RESPONSE TO COMMENTS

FORT LEWIS NPDES PERMIT NO. WA-0021954

Figure c15: Solo Point DMR Summary for Effluent Total Residual Chlorine (2/04-6/08)

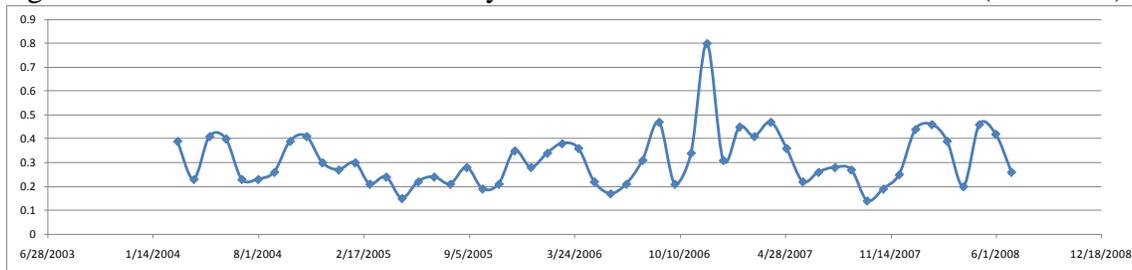
Section I, Subsection B, page 10, #7, first sentence: The permit limitations for total residual chlorine (TRC) are 0.36 mg/L average monthly and 0.50 mg/L for maximum daily. Daily TRC concentrations for 2007 and 2008 for the WWTP ranged from 0.10 mg/L to 0.34 mg/L. Requiring a MDL of 0.010 mg/L seems excessively low and would serve no purpose for evaluation the actual discharge of chlorine. Request that the MDL for chlorine be revised to 0.10 mg/L.

Because the proposed value is also less than the permit limit for TRC **EPA agrees to revise the chlorine MDL to 0.10 mg/L.**
